APPLICATION NO.	FILING DATE	FIRST NAMED INVENTOR	ATTORNEY DOCKET NO.	CONFIRMATION NO.
10/632,854	08/04/2003	Chung-Kuang Lin	BHT-3118-43	3444

Office Action Summary

FIG. 3

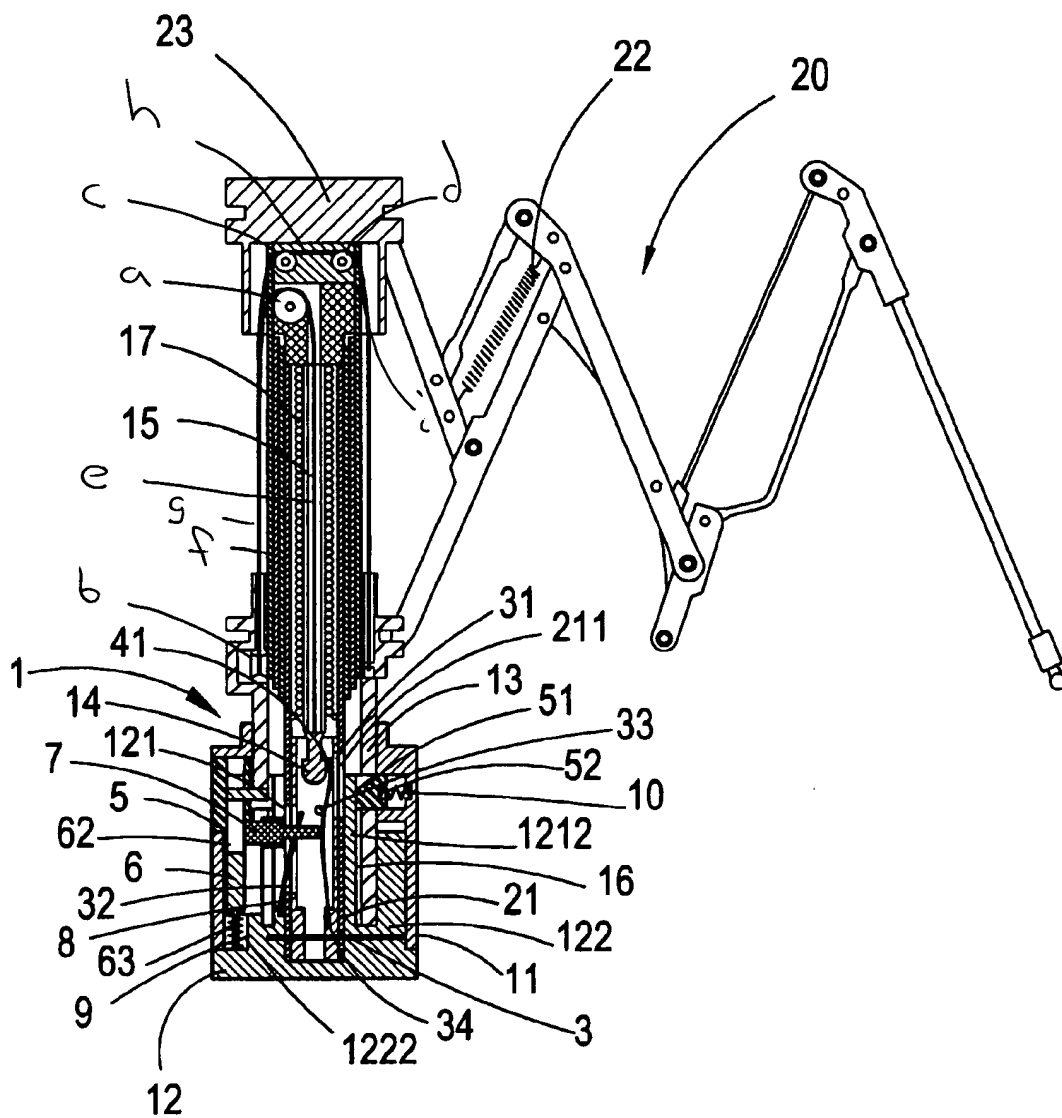
Claim 5 is rejected under 35 U.S.C. 103(a) as being unpatentable over Shih in view of Wu (5,617,889). Shih teaches an automatic umbrella (Fig. 3) comprising: a shaft (2) with a plurality of telescoping tubes, an upper notch (23), a lower runner (13), a rib assembly (20), an opening spring (17), closing springs (22), a control means (in handle 1) with a push button (7) and a locking head (14), first through fourth guiding rollers (a, b, c, and d, respectively; see attachment A), and a rope (15) with five sections (e, f, g, h, i; see Attachment A). For claim 5, Shih fails to teach a control means in the handle with a push button, an upper latch, a lower latch, and a locking head. Wu teaches a control means (in handle 3) with a push button (41), an upper latch (422), a lower latch (430) and a locking head (441). It would have been obvious to one of ordinary skill in the art at the time of the invention to modify the umbrella of Shih by using an alternate type of control means in the handle, i.e. using the mechanism of Wu in place of the mechanism presently used, since these mechanisms are functional

equivalents and it appears that either type of mechanism would work equally well in opening and closing the umbrella of Shih. Some deciding factors on which mechanism to use including economic reasons, personal preferences, etc.
